Re: SR 162/6 Puyallup River (McMillin) Bridge-New Adjacent Bridge-Section 106 Consultation

# New Puyallup River Bridge

## ADJACENT TO THE McMILLIN BRIDGE

Bridge No 162/6

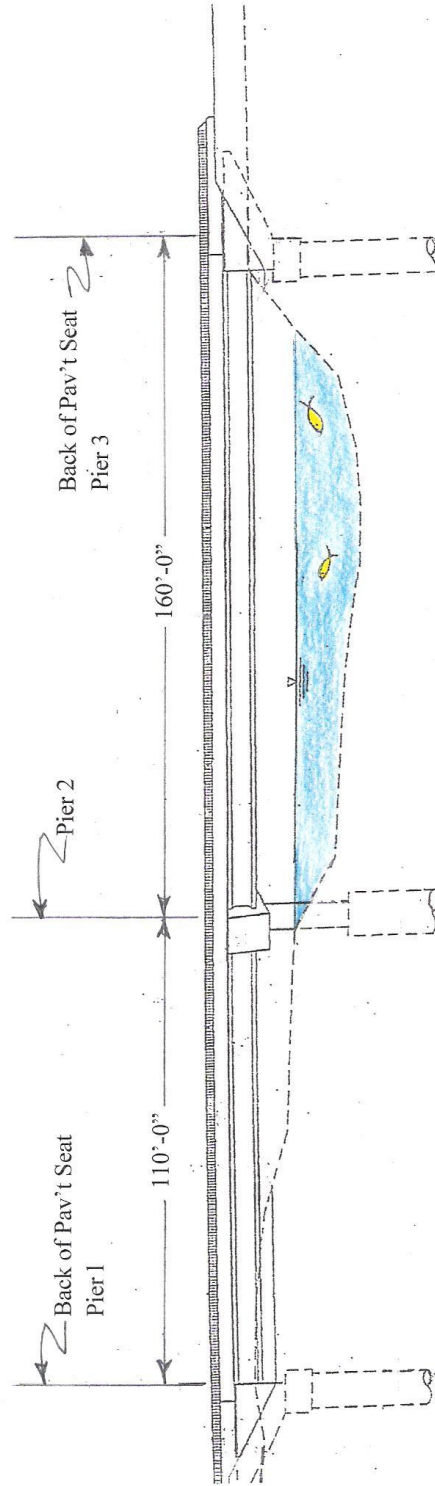
In selecting the span configuration for the new bridge it must be recognized that the existing McMillin Bridge will remain in place. Mr. Schanz stated: "If the bridge [McMillin Bridge] is replaced at the current location, most floodplain impacts can be avoided by **replicating the existing total bridge length.** A single span of 200 feet (the maximum for conventional girders) would reach from the top of the right bank to the landward edge of a low terrace on the left bank.

This would span the entire mapped 100-year floodplain and avoid new fill within the flood hazard area. It would also maintain the existing level of floodplain connectivity beneath the bridge by spanning a low terrace on the left bank. Some additional fill may be needed on the upper portion of the left bank to connect with the existing roadbed, but this would occur well above the 100-year flood elevation.” I realize this was intended as a recommendation by Mr. Schanz, subject to development by the WSDOT team. However, the selection of a two span bridge with spans of 110 and 160 feet is completely different than his recommendation. I also recognize that the Site and Reach Assessment report is a draft and is supposed to be finalized after the final bridge configuration is developed. There needs to be an explanation why the recommendation by Mr. Schanz for the 200 foot span has been so drastically modified. Further, adding the 110 foot span instead of using the recommended placement of fill material, will increase the cost of the new bridge, and have significant long term costs for structural inspections and bridge preservation. Fill material is necessary anyway for the roadway approaches to the bridge, so it seems reasonable to follow Mr. Schanz’s recommendation. Most important, however, the configuration has not resulted in fulfilling the hydrological requirements of avoiding a pier within the wetted perimeter of the river.

I realize that using a 200 foot long precast, prestressed girder, is near the structural limitations for that type of span configuration. However, it appears the column at Pier 2 could be located about another 10 feet landward to avoid any impacts to the active channel. This would be very practicable, would provide a 170-foot span, the same as the McMillin Bridge, and conform to the recommendation by Mr. Schanz.
